Re: Roundabout Design Report **Eastonville Road/Rex Road** EPC PCD File No. CDR2321 LSC #224380

V3_TIS - Rex Roundabout.pdf Markup Summary

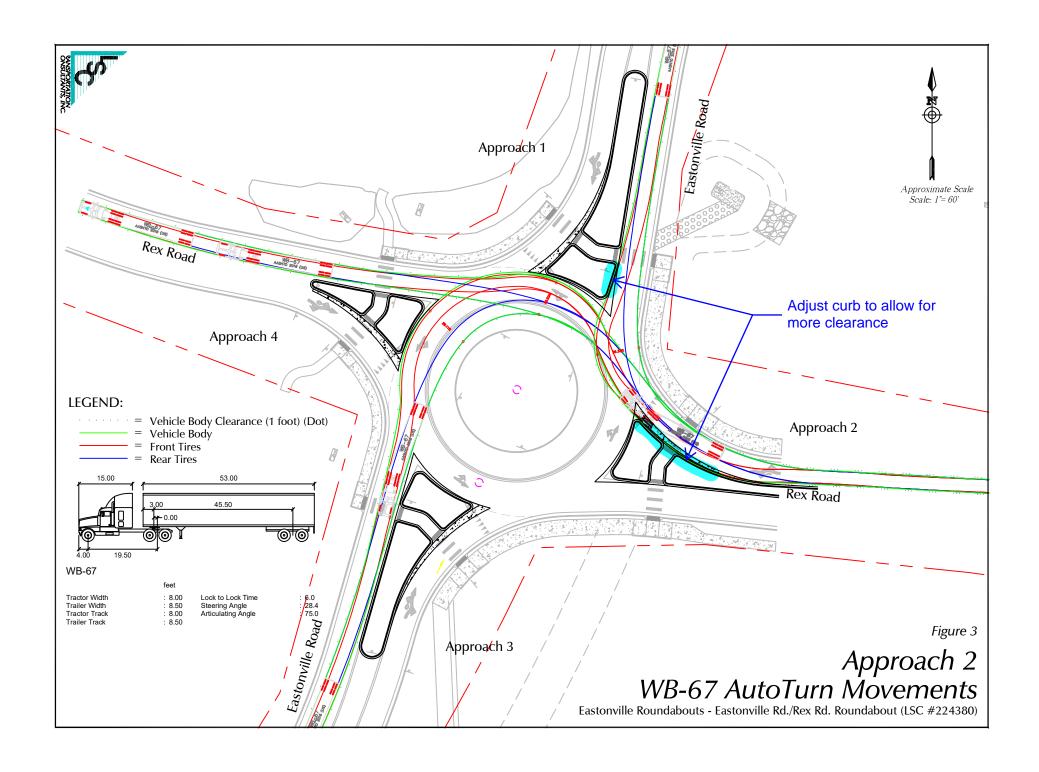
Status: Color: Layer: Space: Adjust curb to allow for more clearance

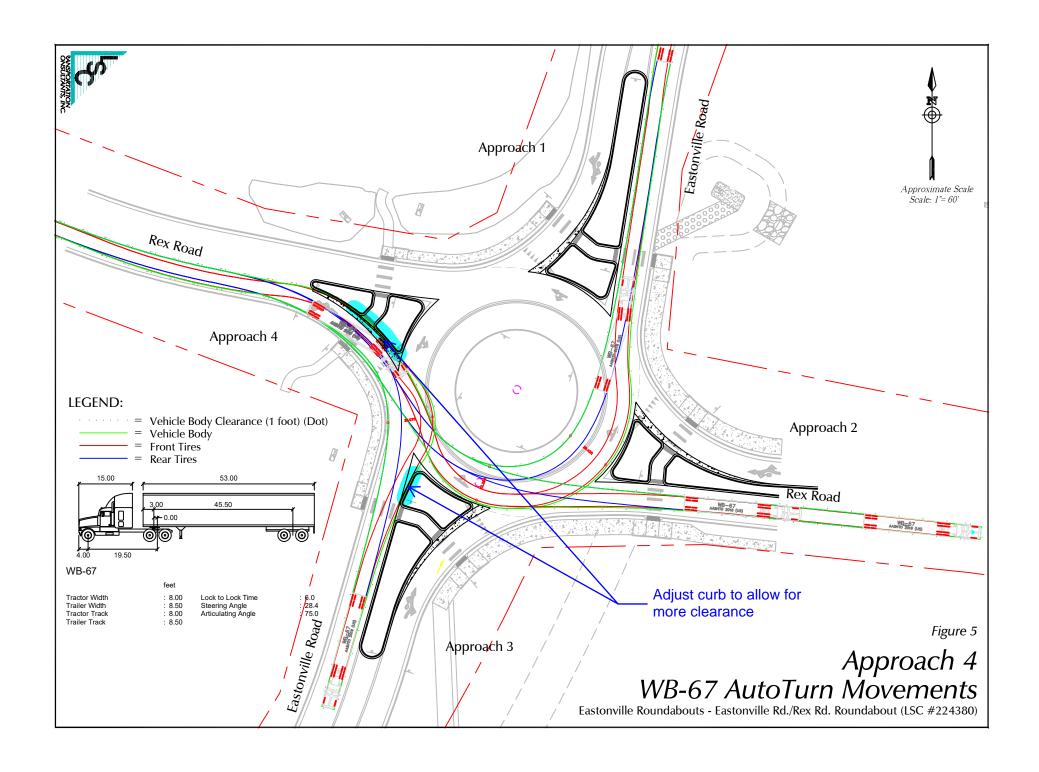
Status: Color: Layer: Space: Adjust curb to allow for more clearance
